Road & Bridge Design Publications

Monthly Update – February 2026 (reissued)

Revisions for the month of **February** are listed and displayed below and will be included in projects submitted for the **June** letting.

STANDARD PLAN FOR GUARDRAIL DEPARTING TERMINAL TYPES B, T, & MGS			
(SPECIAL DETAIL)	02/23/2026	R-66-E	SHEET 1 OF 4
FHWA APPROVAL	PLAN DATE

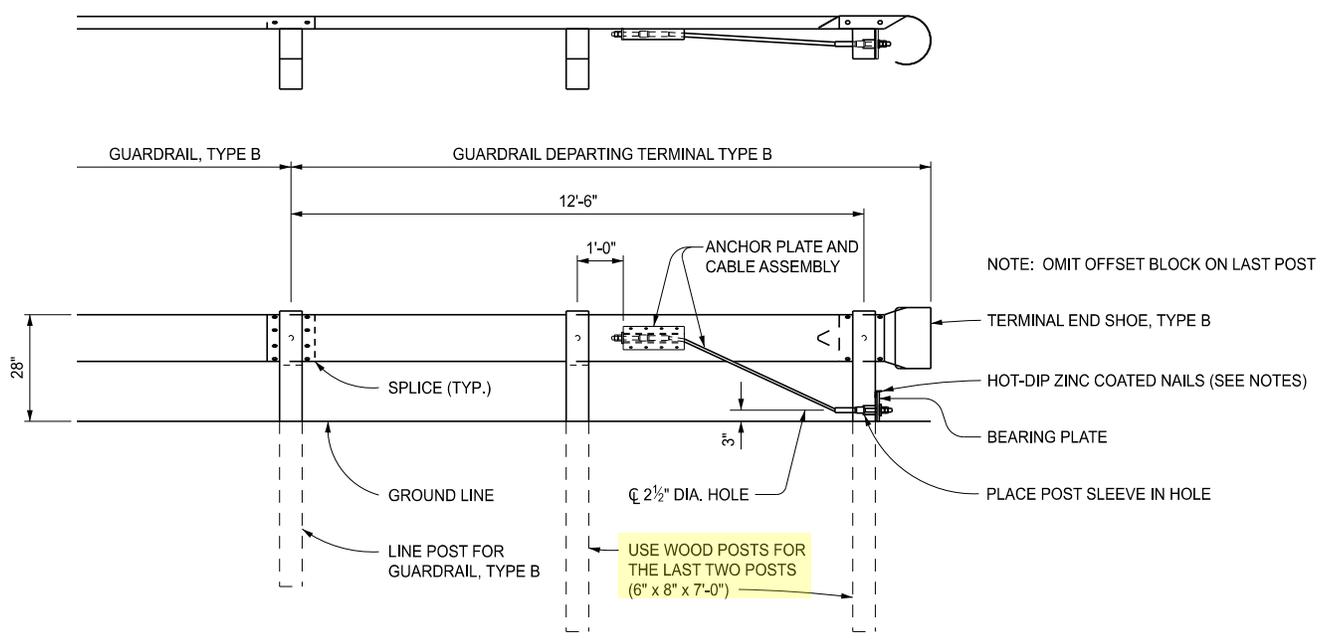
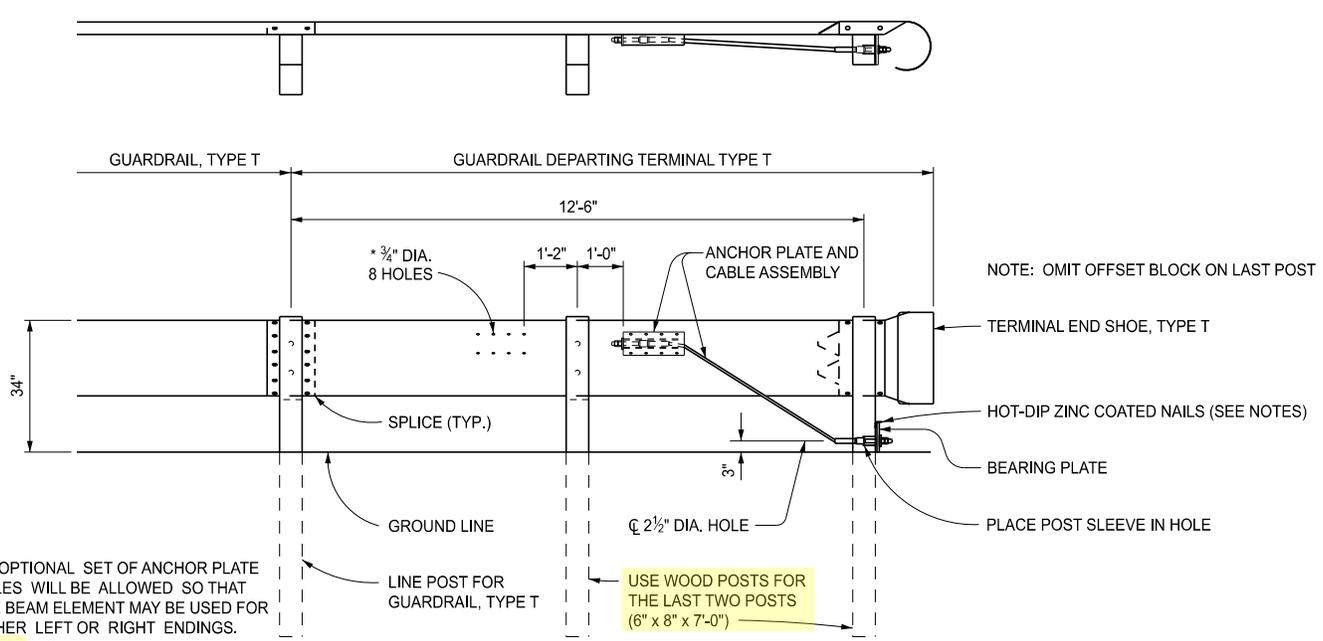
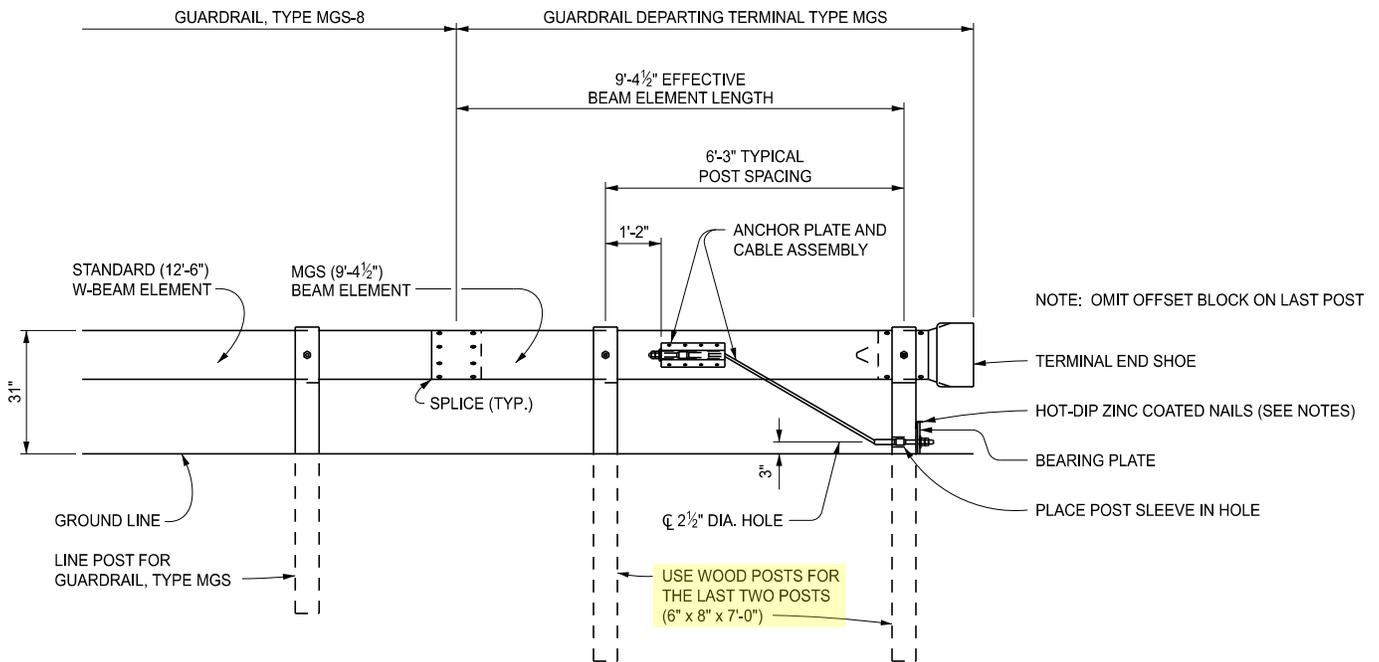
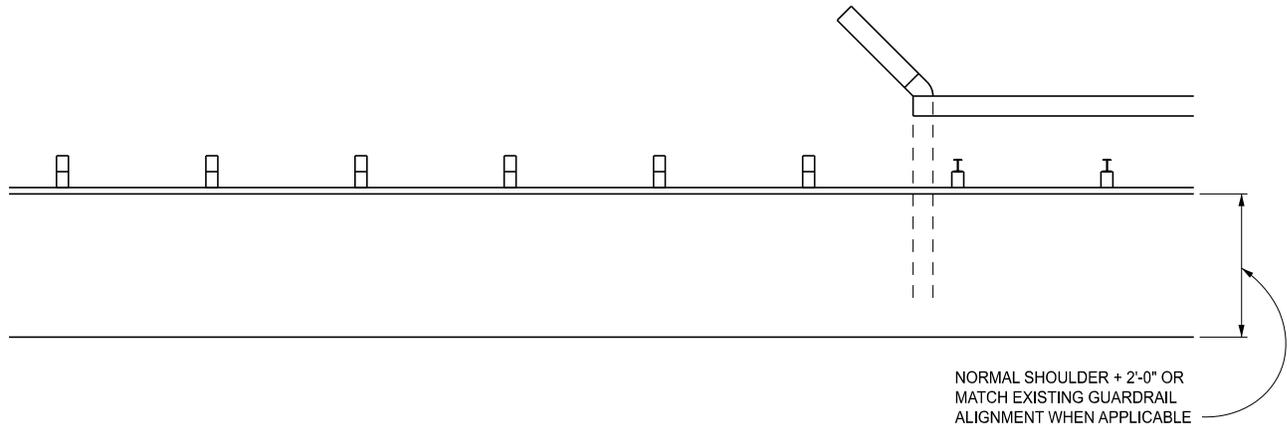
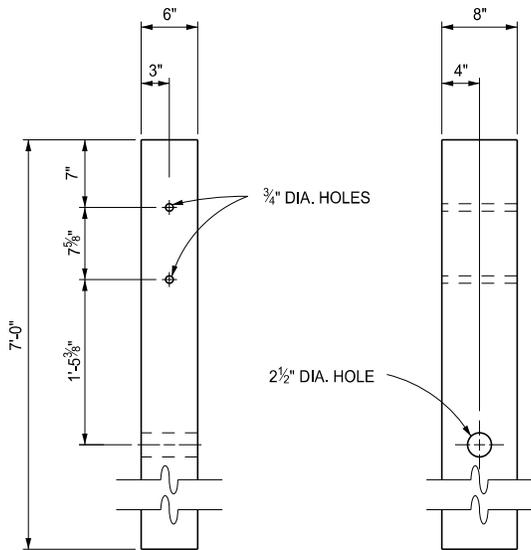
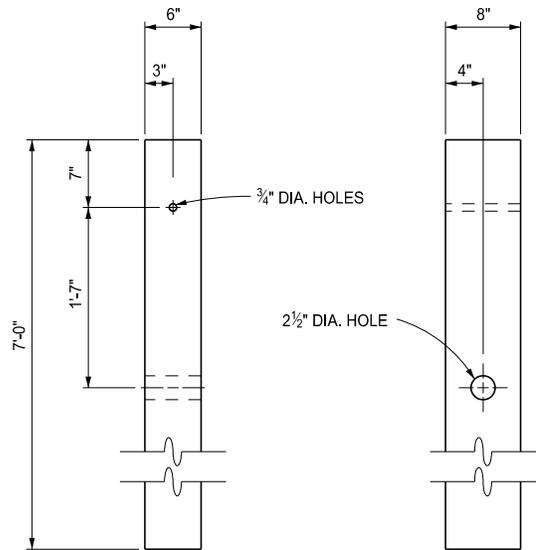
R-66-E: Guardrail Departing Terminal Types B, T, & MGS:

Converted notes and callouts to active voice.

R-73-F

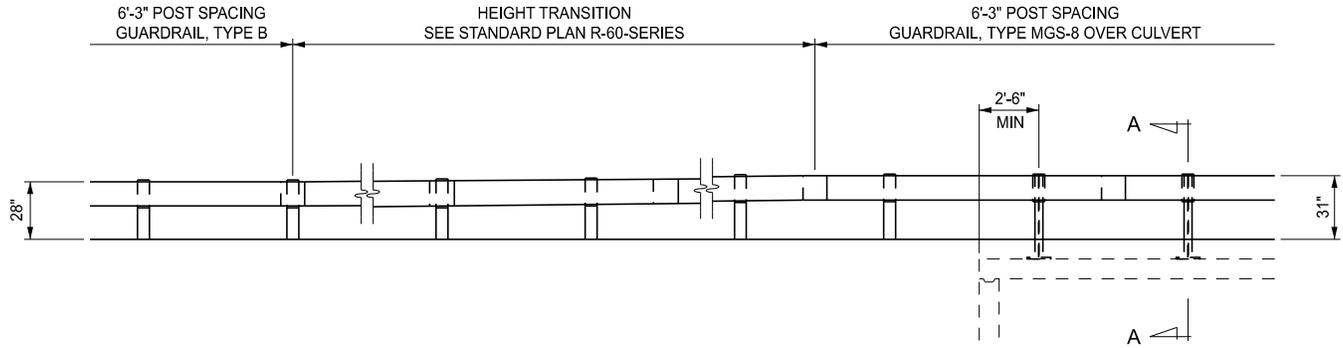
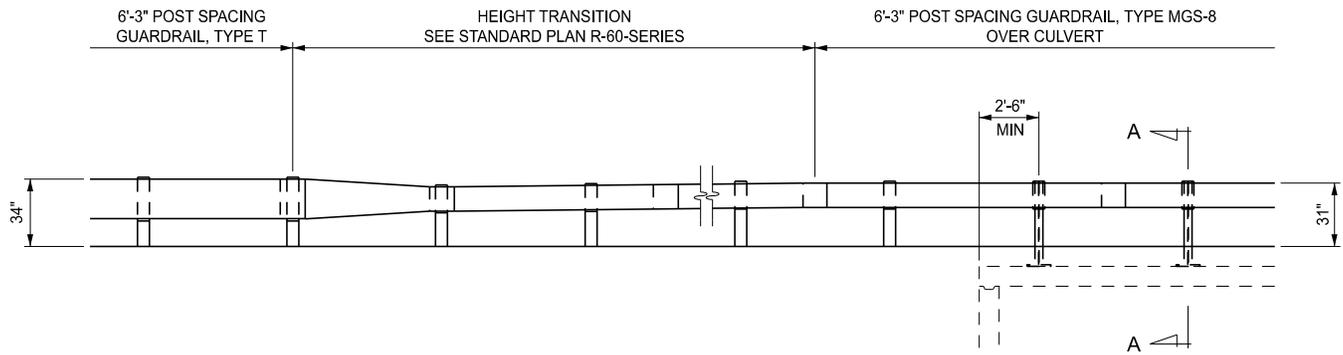
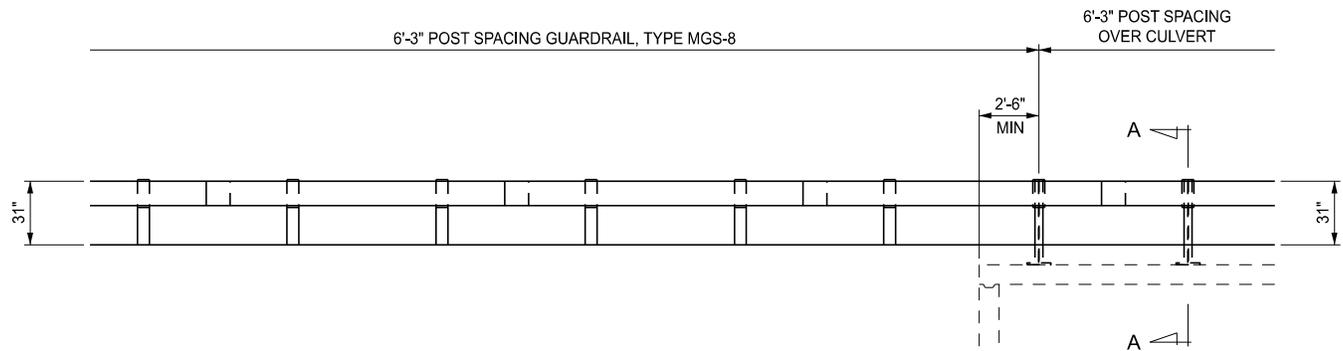
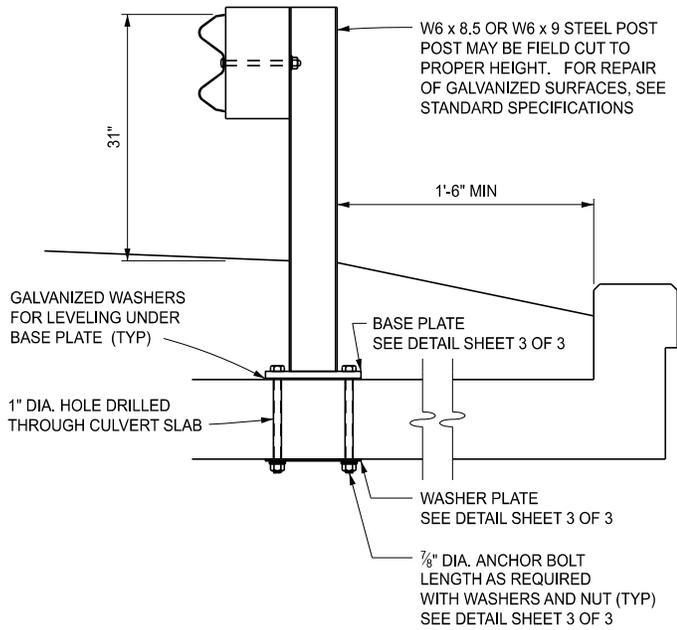
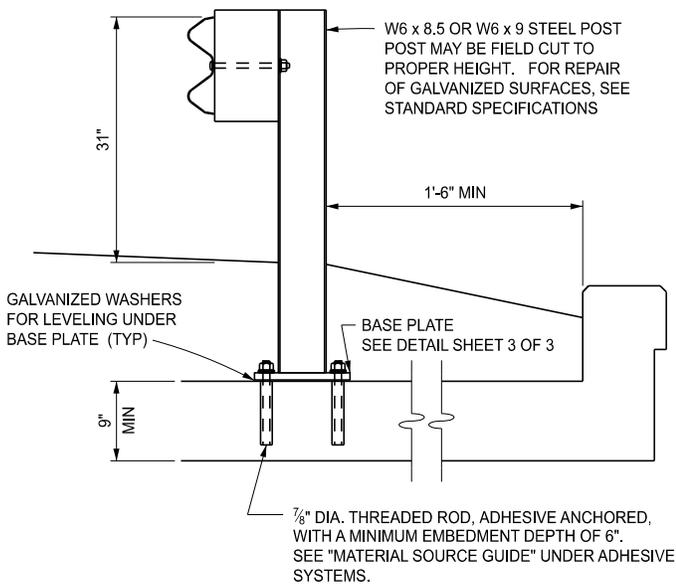
R-73-F: Guardrail Long Span Installations:

Converted notes and callouts to active voice.

TYPICAL STONE BASKET SECTION

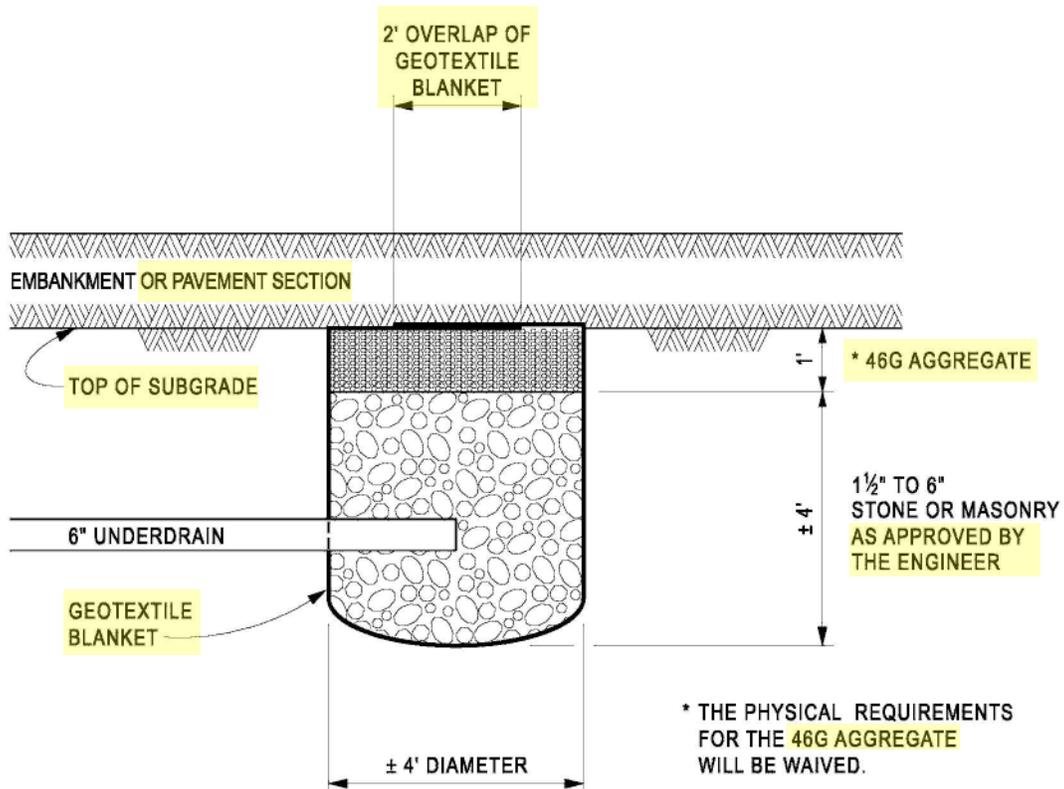
4.06.06: Stone Baskets:

Updated stone basket details to current practice. Major revisions include allowing use under pavement sections, the use of 46G aggregate instead of 6A, and specifying geotextile blanket instead of geotextile or filter cloth (which completely covers the aggregate backfill with an overlap on the top). Also converted section to active voice.

Use stone baskets to drain springs that occur below the roadway. Construct the stone basket by making an excavation at the spring head 4' in diameter and approximately 5' below the bottom of embankment or pavement section. Place geotextile blanket in the excavated hole and backfill with 1½" to 6" stone or masonry, and a 1' thick layer of 46G open-graded aggregate. Use a 6" diameter underdrain to dissipate water from the stone basket. Show the location of the stone basket on the typical cross section and detail the following sketch on the plans.
